ADDENDUM No. 4

Date: January 20, 2026 **Project No:** M20051

Project Name: Request for Proposal: Town of Shelburne, Well 1 Upgrades

TYPICAL MECHANICAL THRUST RESTRAINT FOR PVC PIPE

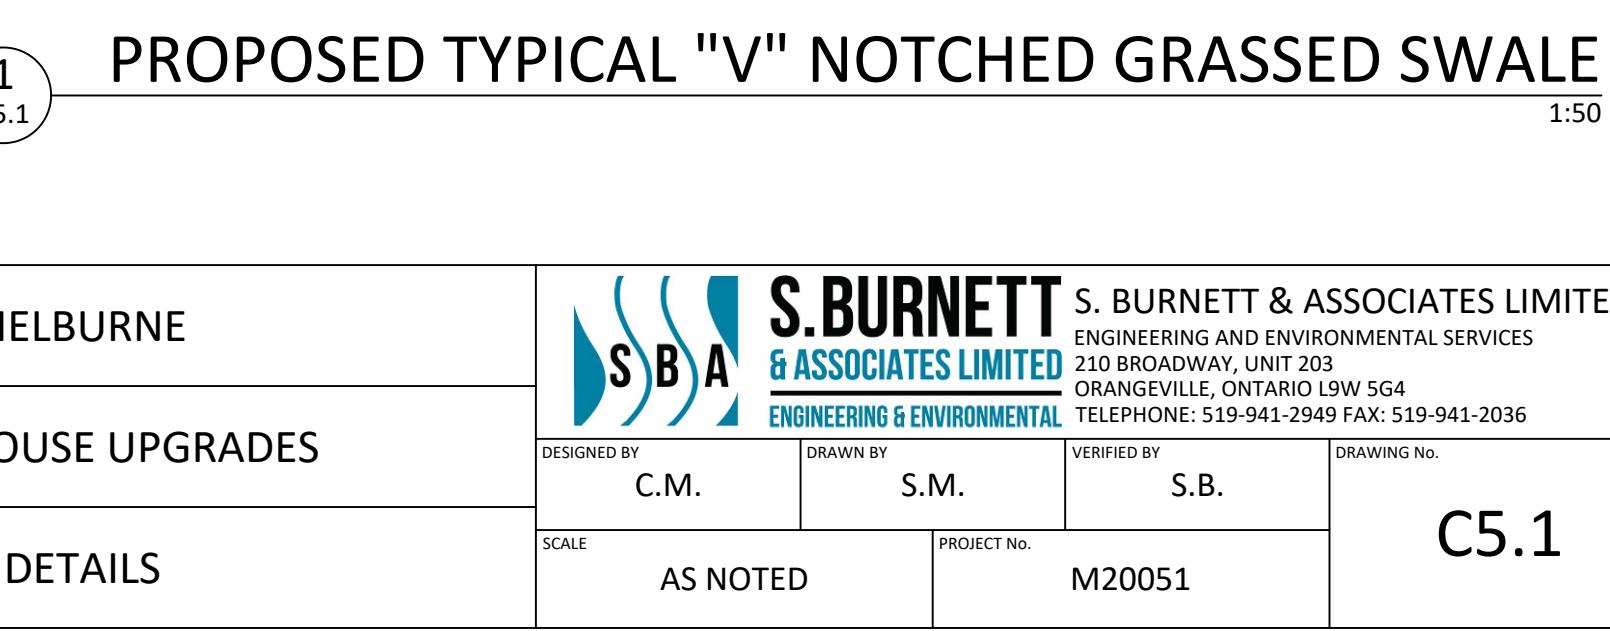
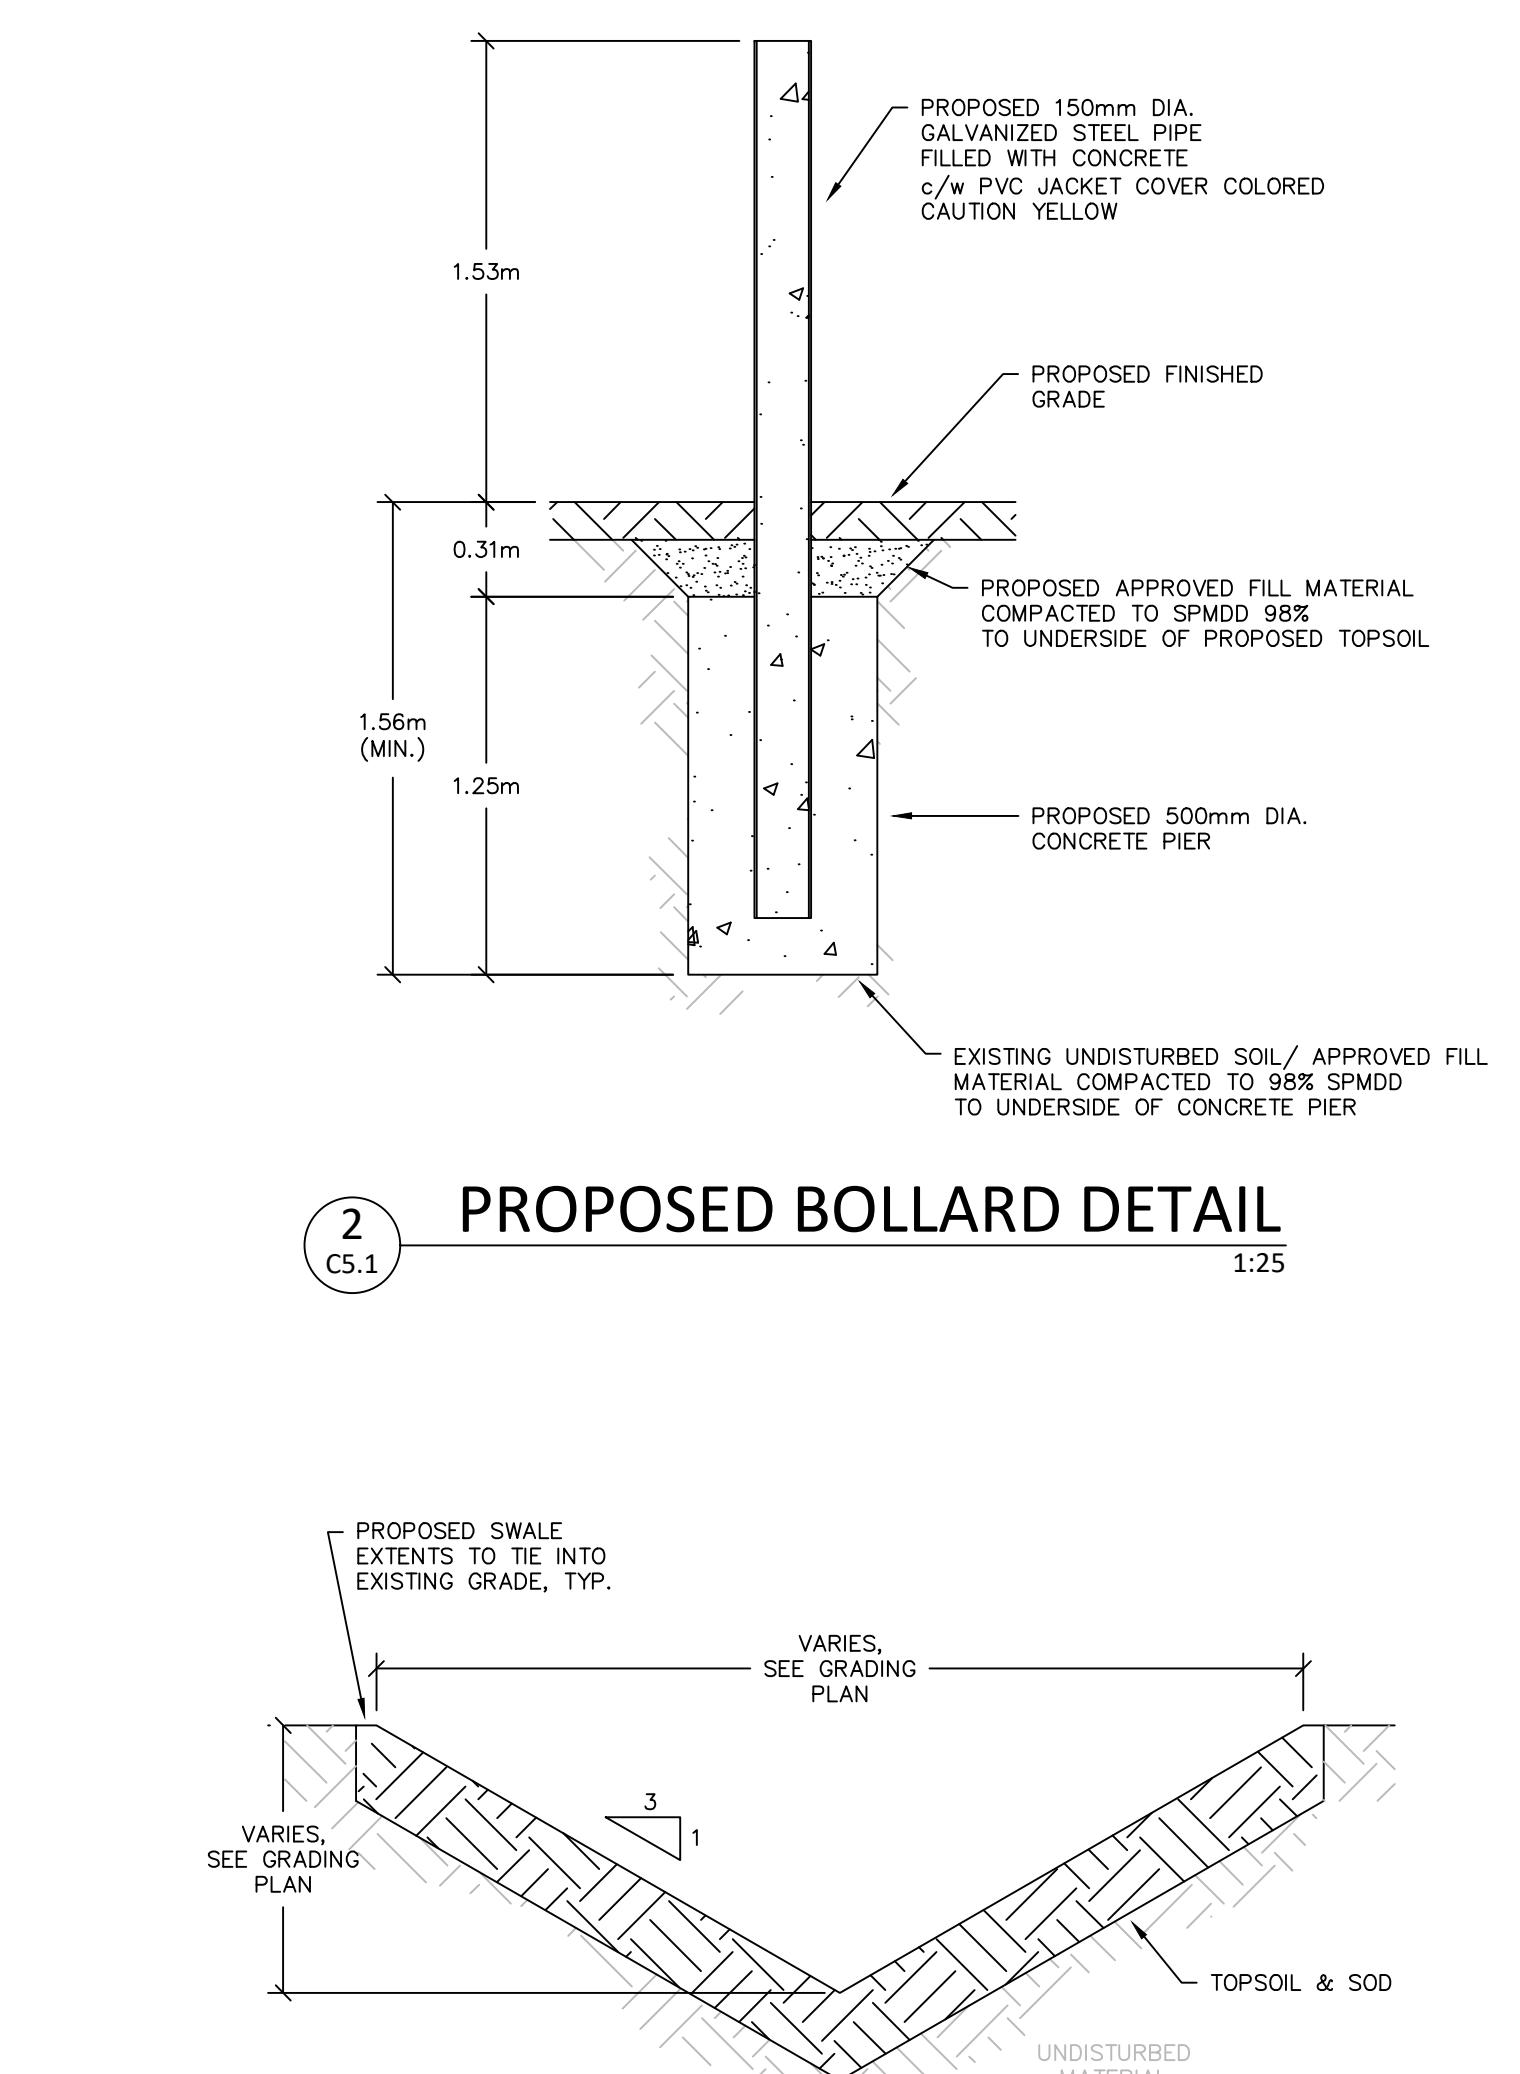
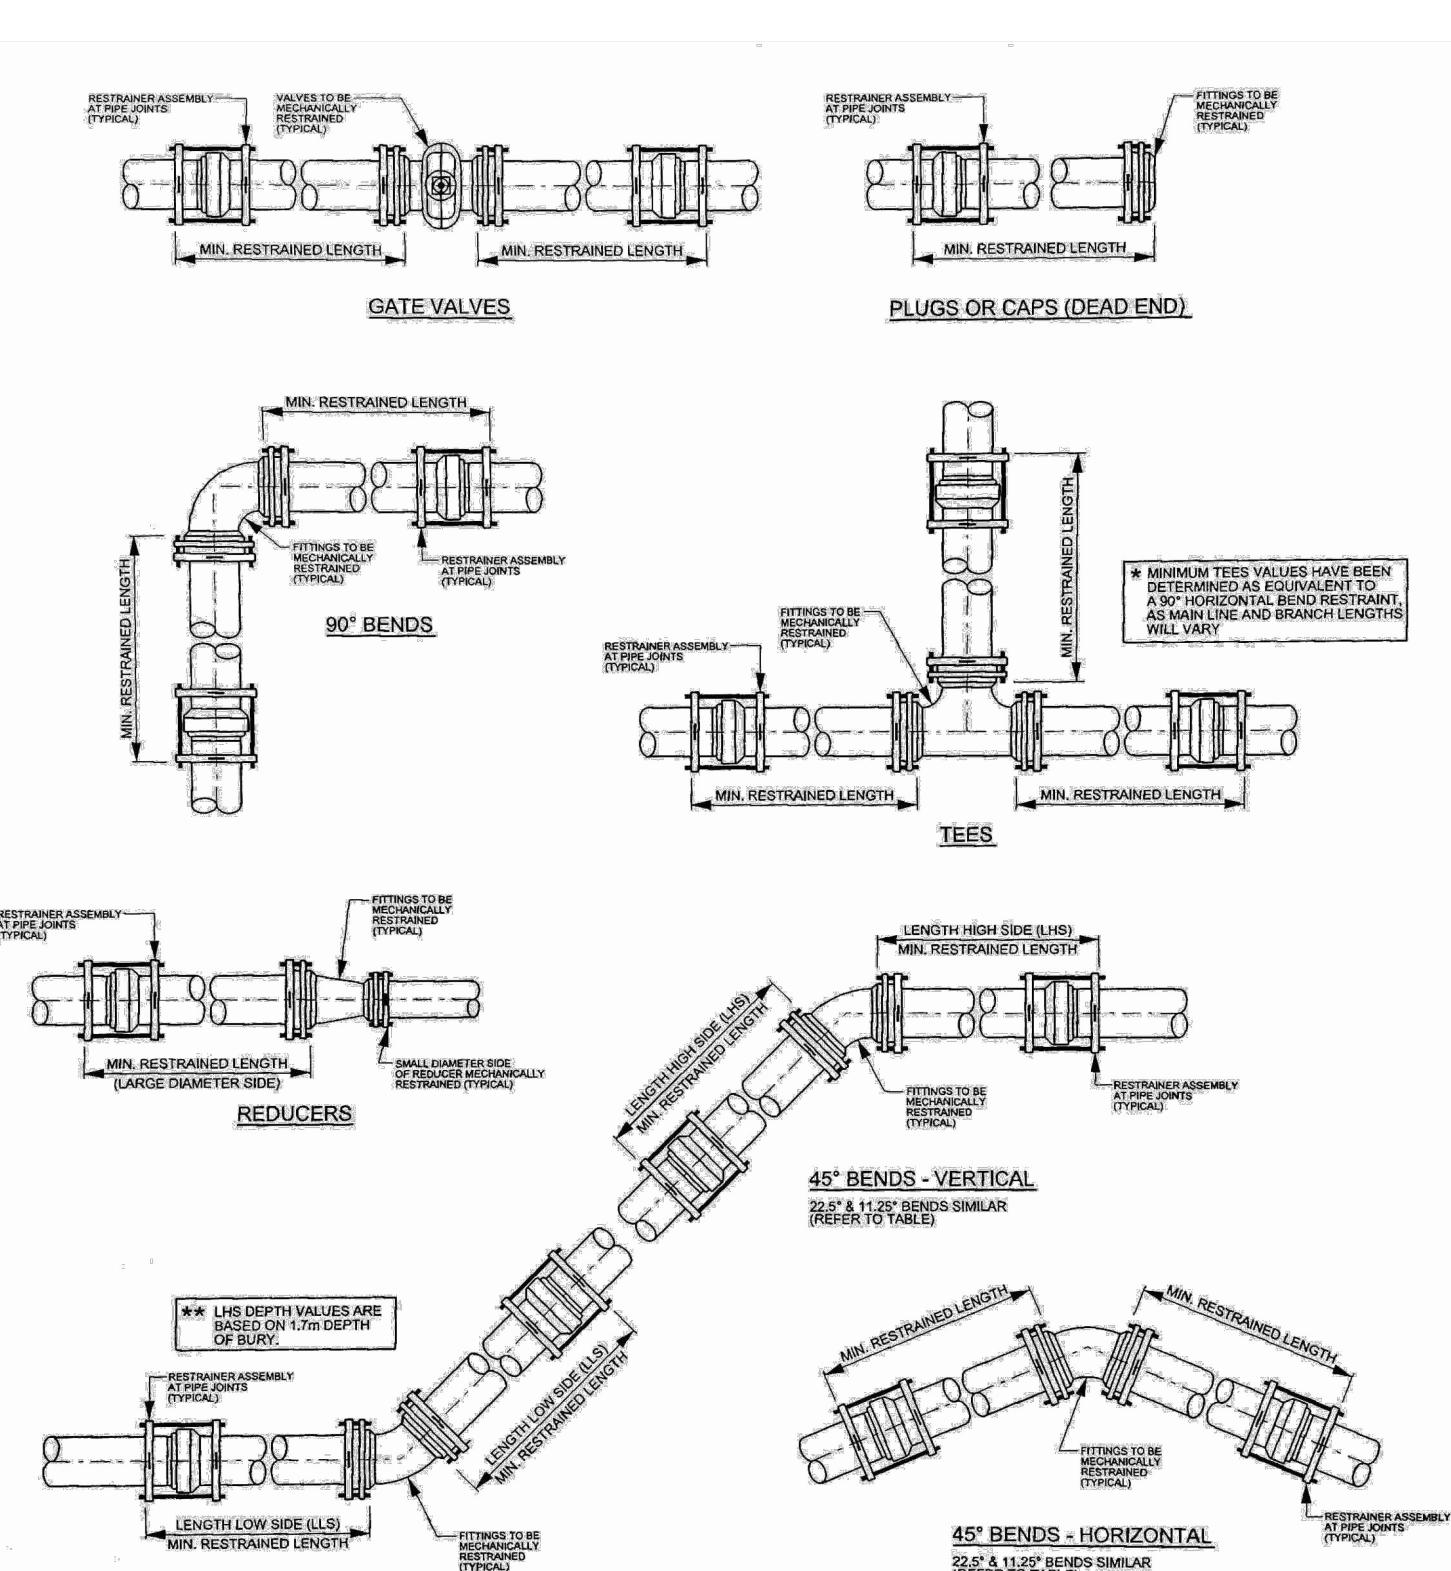
Question 9: *Note on Drawing C2.2 indicates mechanical restraints and blocking is required on watermain pipe bends, Detail 3 on C5.1 indicate blocking is not permitted. Please confirm if blocking is required.*

Response 9: Blocking is required. Drawing C5.1, Detail 3 has been removed. Please see attached.

NOTE:
1. BLOCKING IS REQUIRED ON NEW INSTALLATIONS.
2. TABLES OF VALUES ARE BASED UPON PVC PIPE MANUFACTURE'S RECOMMENDED MINIMUM RESTRAINED LENGTHS FOR PVC PIPE.
